**Service Notice Number:** 20160705-4

**Warning: Potential Damage To Input Wiring**

**Product(s) Covered:**

### Old Studs to be replaced

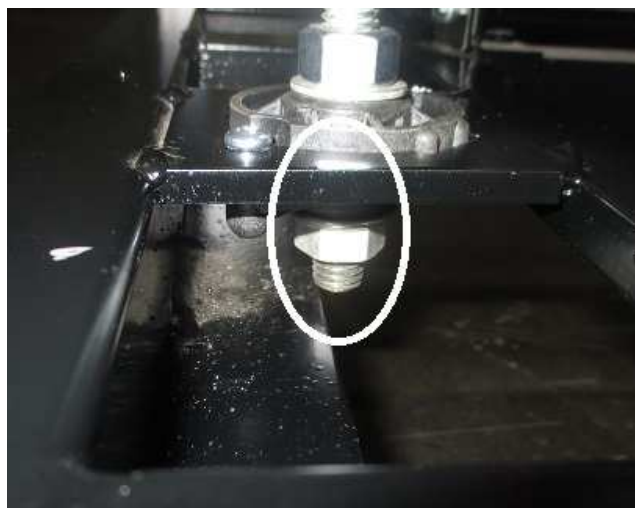
Machine racks that fall within the above serial number range have an isolated work stud that may come in contact with rack frame, resulting in potential damage to the grounding conductors of the electrical system.

If you are aware of a customer that has a rack for one of the above products that falls within the Serial Number range on the above chart, please contact them. For any rack(s) with front fork access that meet this criteria, please submit Parts/Accessory (P) claim referencing the rack product number, serial number, and above service notice number. Replace both studs ordering a quantity of two 9SM26100 (see locations in photos below).

**New Studs after repair**
